We are in the process of consolidating the three subject properties into a single parcel. One of the items that was identified at Sketch Plat was the requirement to obtain a Variance to the Integrated Development Ordinance (IDO) Section 5-1(D)(2) and a Wavier for Table 7.2.29 of the Development Process Manual (DPM) to allow the existing non-conforming 6'-8" wide sidewalk and zero setback along Central Avenue to remain.

This request is waiver for all three dimensional standards for the Main Street Pedestrian Realm as identified in Table 7.2.29. We are seeking relief from the Frontage Zone and Landscaping Buffer Zone as well as a waiver to reduce the Sidewalk Width from 10' minimum to allow the existing 6'-8" concrete sidewalk to remain.

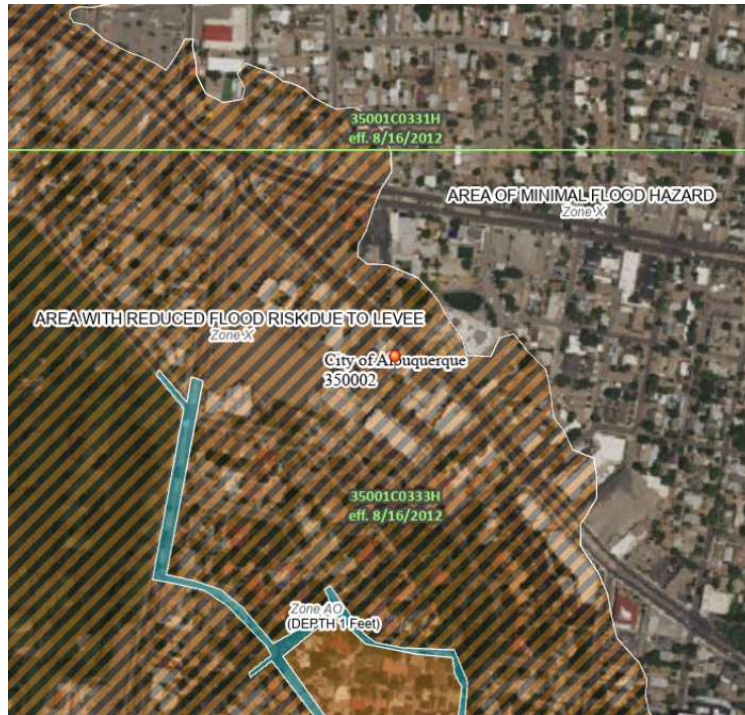
**There have been two City projects along Central Avenue in the recent past. The first was a Lane Diet project that reduced the travel lanes from two each direction down to a single travel lane for east and west bound traffic. The second project was for the ART dedicated lane. Neither of those projects made any modifications to the curb and gutter location or sidewalk width. Furthermore, the buildings on site along the Central Avenue were constructed prior to 1959 and the adoption of Zoning Codes and implementation of the IDO. This sidewalk waiver does not conflict with any known goals or provisions of the City, or County.**
